June 17, 2026

Re: 210 – 222 College Avenue East – Transportation Impact Study Update & Response to Comments (File No. OZS26-003)

Transportation-related City of Guelph staff comments have been provided within two memoranda prepared by City's Development Planning Department, dated May 2026, and from the Engineering and Transportation Services Department, dated April 29, 2026. These comments are addressed herein, and responses have been organized by comment with a summary discussion which refers, as appropriate, to technical materials provided within this letter. Staff comments are provided in **Appendix B** for reference.

Appendix D: Left Turn Warrant

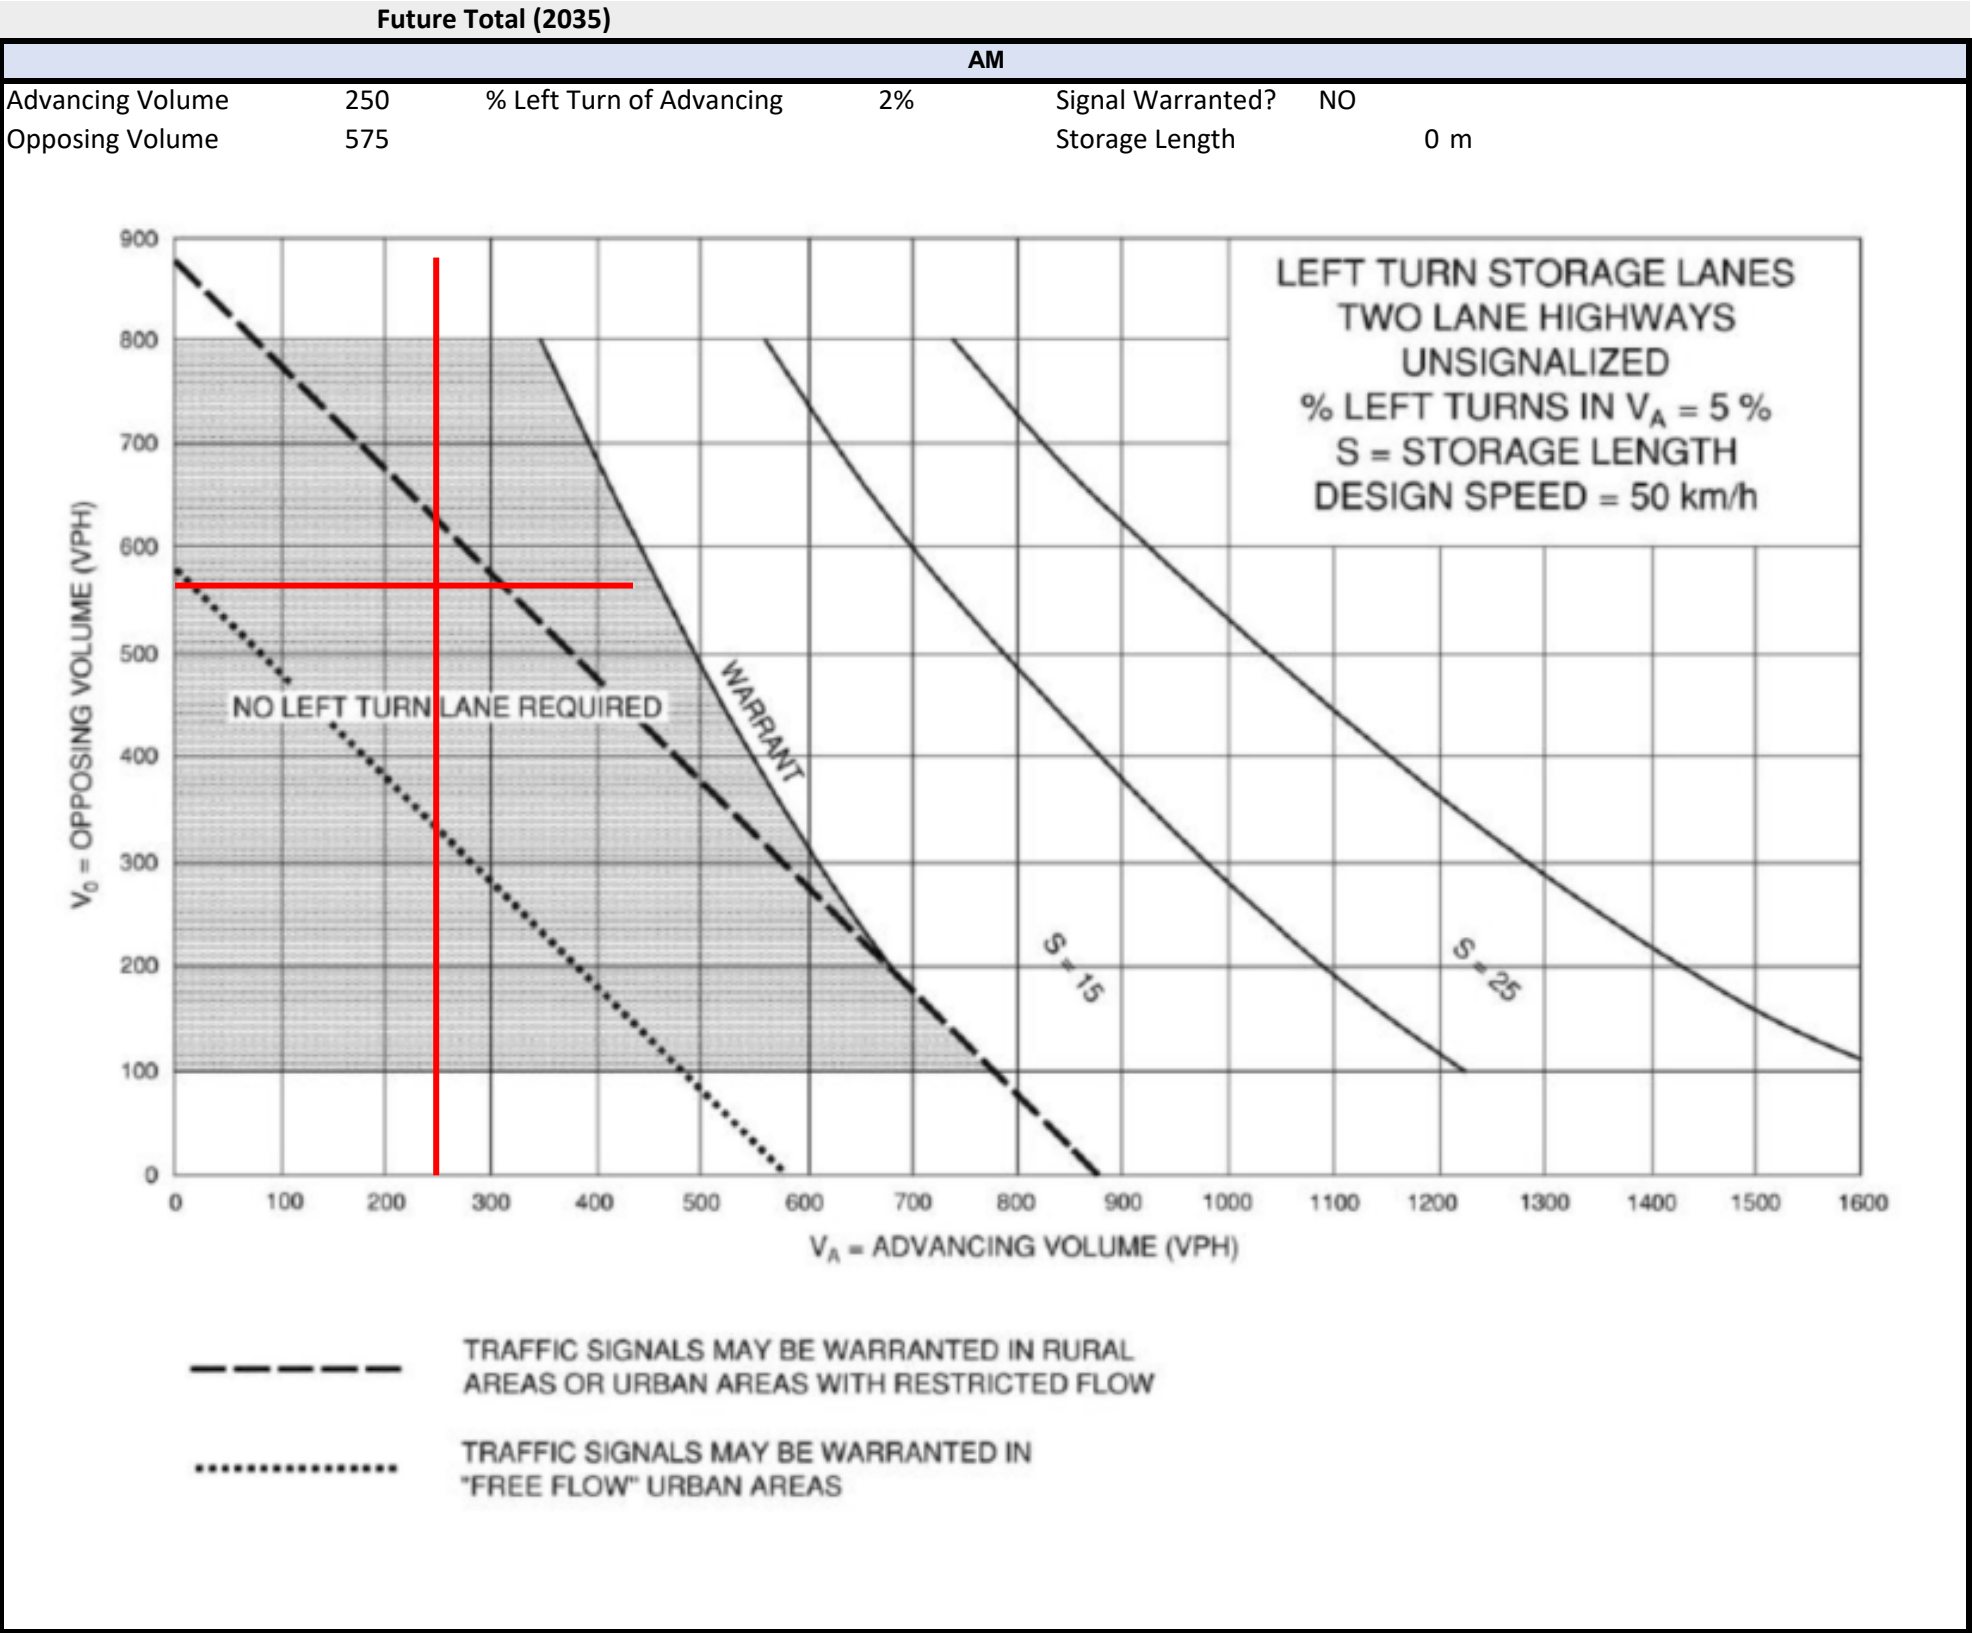
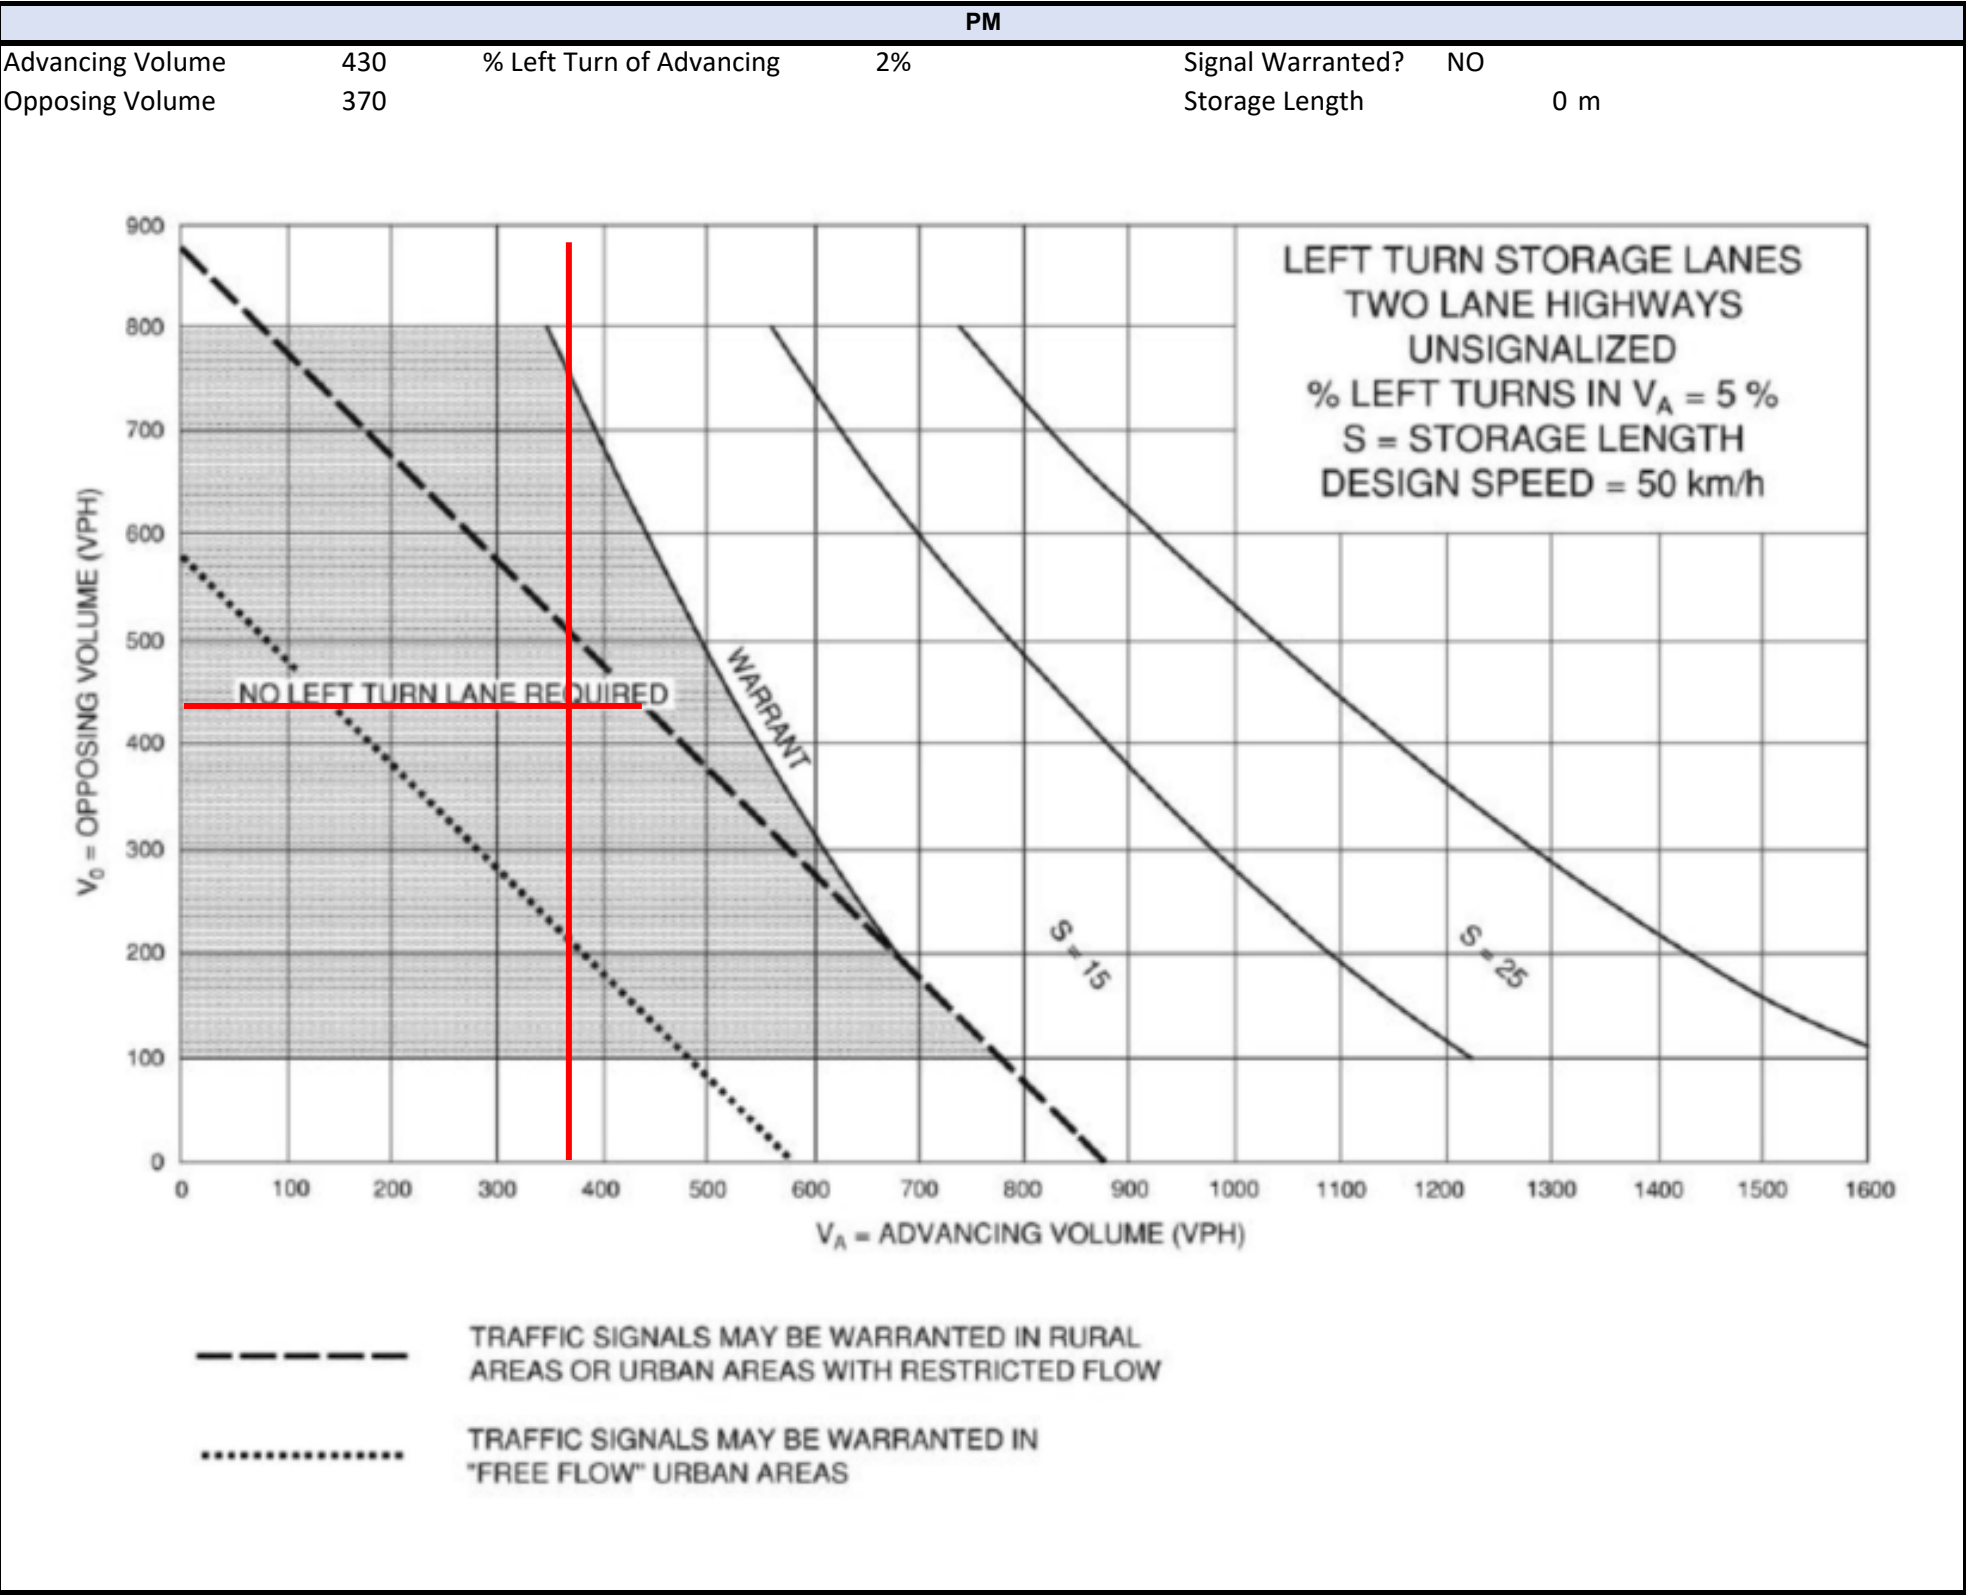
Update the TIS to provide a left-turn analysis at the site access. If warranted, a functional design is to be included to illustrate the proposed lane configuration along College Avenue.

Recommended Storage Length0 metres

210-222 COLLEGE AVENUE EAST SIGHT DISTANCE REVIEW COLLEGE AVENUE / SITE DRIVEWAY - RIGHT TURN DESIGN SPEED OF 50 KM/HR	Project: 210 - 222 College Ave E	Scale 1:300 
		Project No. 8310-04	
		Date: June 17, 2026	Drawing No. SD-01
		Revised: --

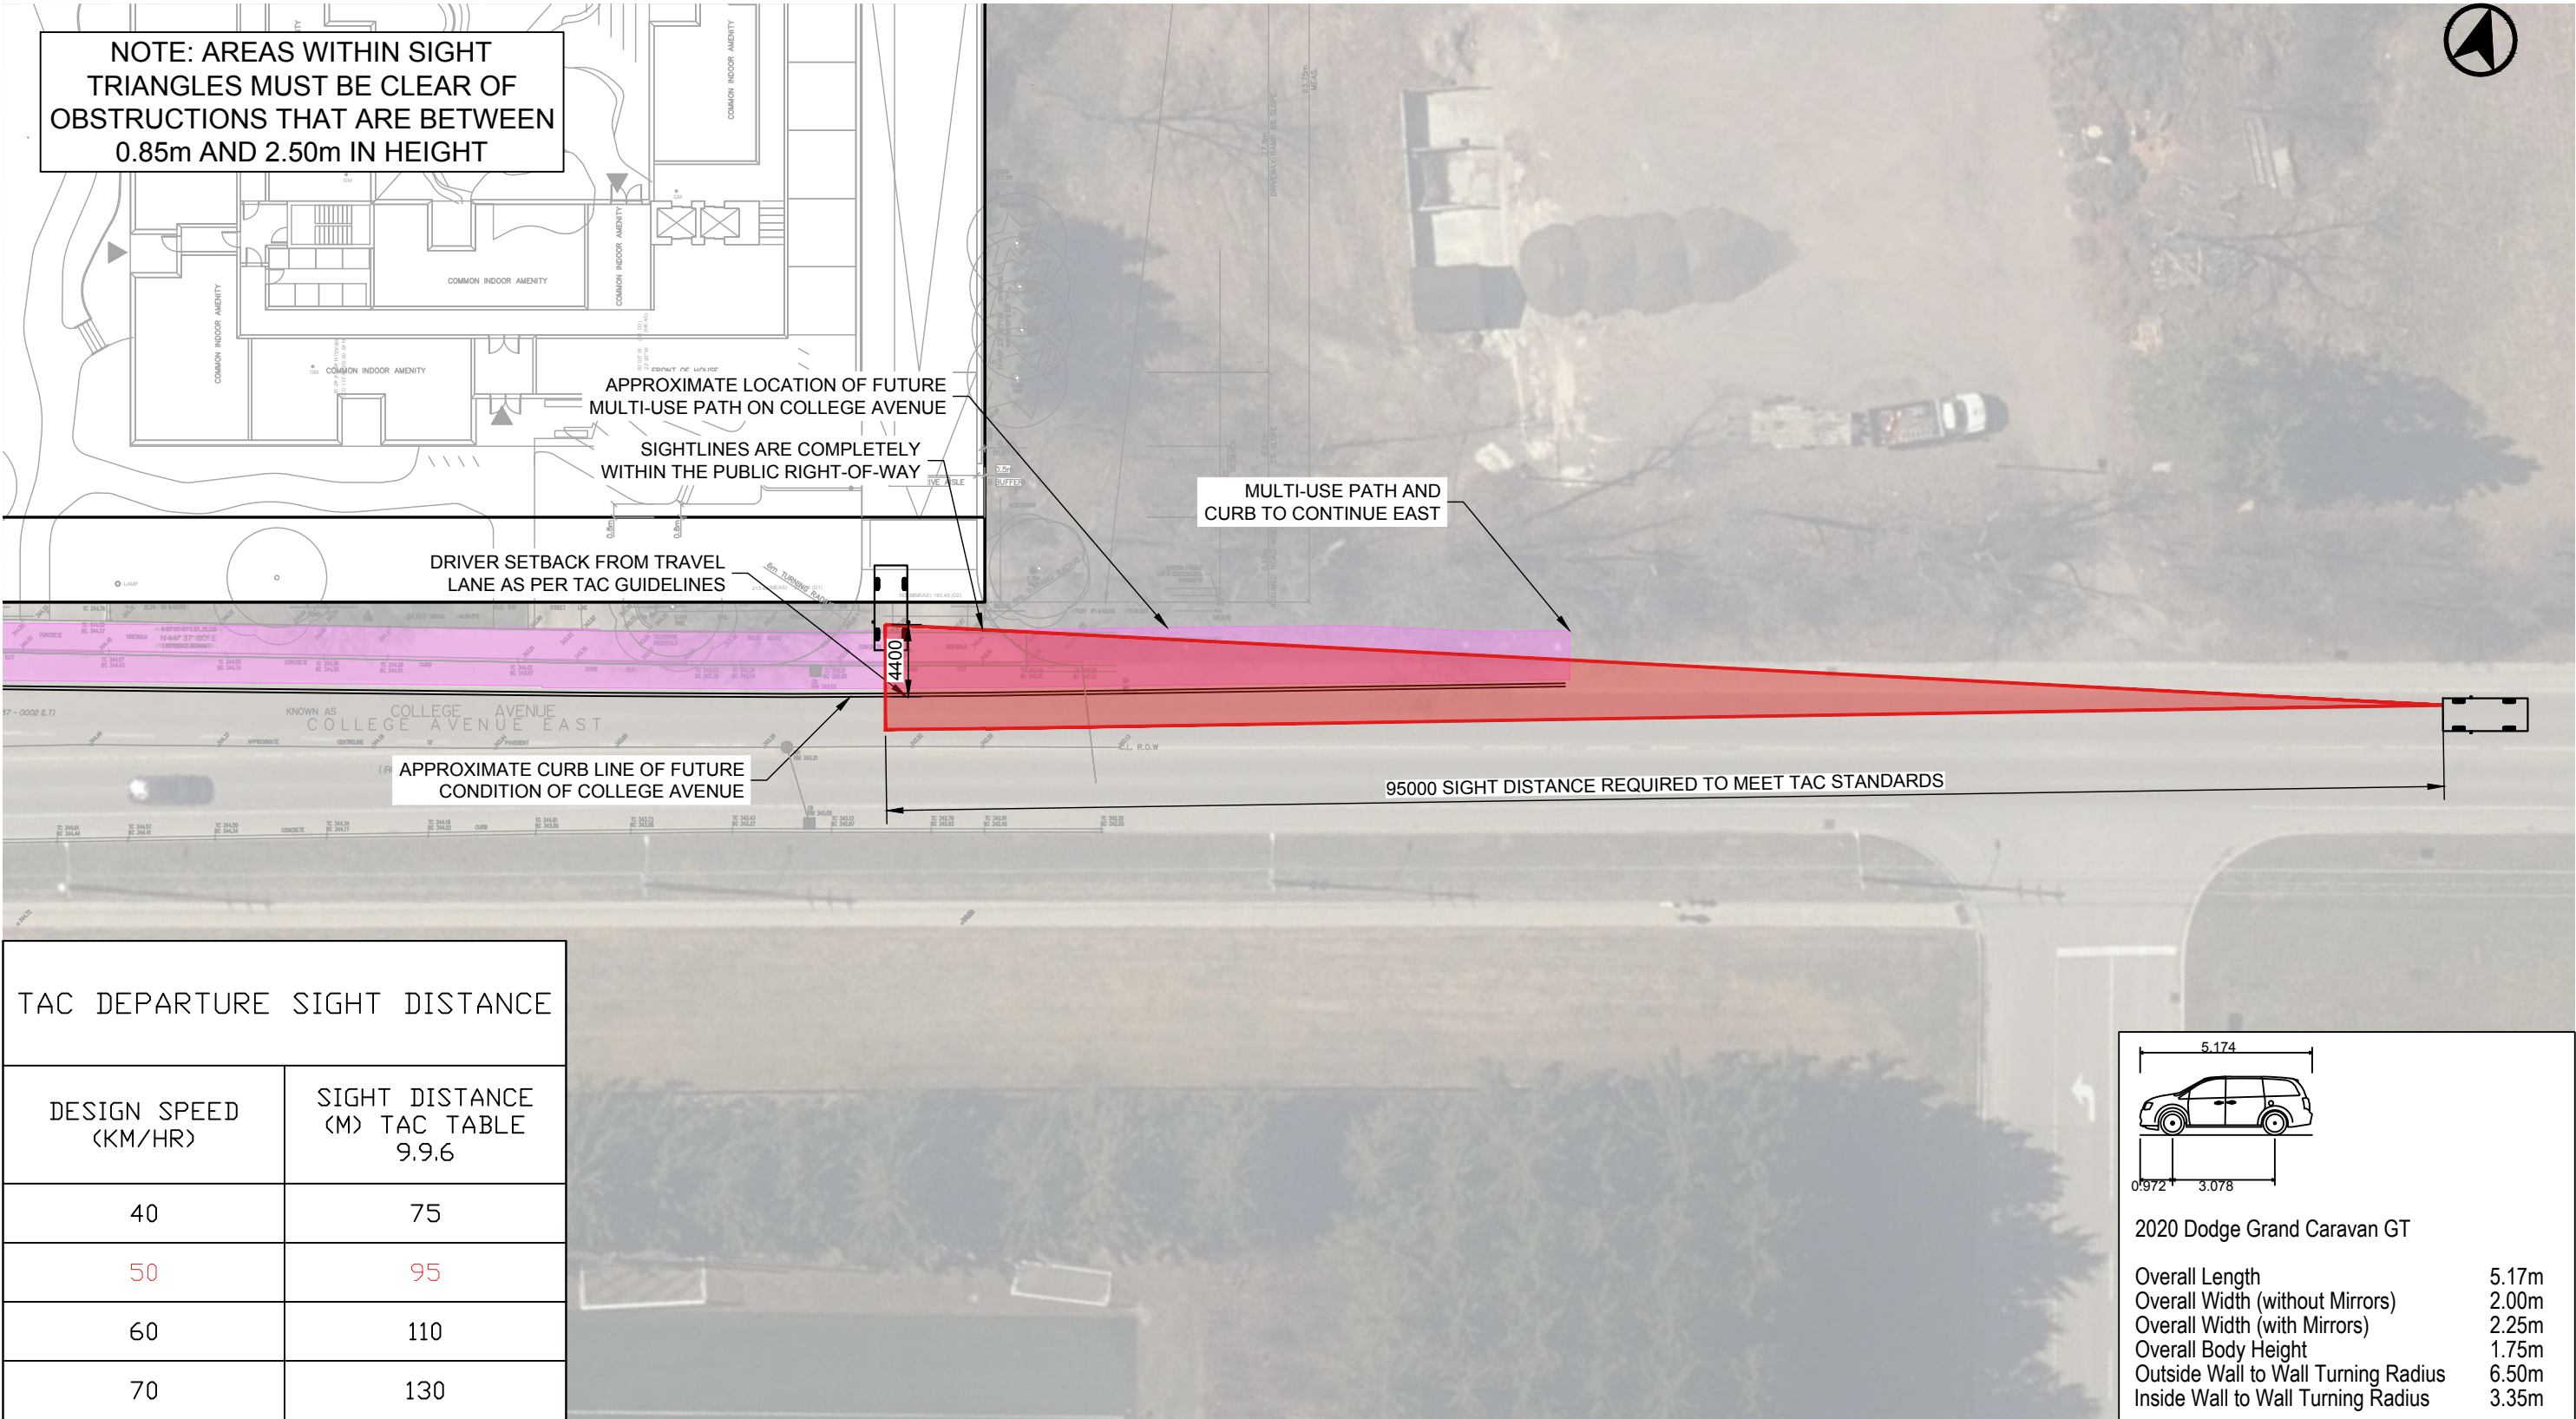
Please provide a sightline assessment at the proposed site access, as visibility may be limited due to the crest along College Ave. Please confirm that adequate sight distance is provided in accordance with TAC guidelines. In addition, the current access geometry appears to extend beyond the easterly property line. Please revise the access design to ensure it is fully contained within the subject property and complies with City standards. Consider relocating the driveway to the west limit of the property to improve sightlines and shorten the walking distance for pedestrians to reach the existing signalized intersection at East Ring Road and College Avenue.

The sight distance figure that illustrates the available 95 m sight distance is provided in **Appendix E** (Drawing **SD-01**).

The sight distance figure that illustrates both the intersection sight distance and vertical sight distance is provided in **Appendix E** (Drawing **SD-02**). The sight distance review concludes that the available sight distance is 94 metres, which does not meet the 105-metre TAC recommendations for the 50 km / h design speed limit.

Although the available sight distance does not meet the TAC recommendations, the driveway is considered appropriate and functional given the following considerations, discussed in greater detail below:
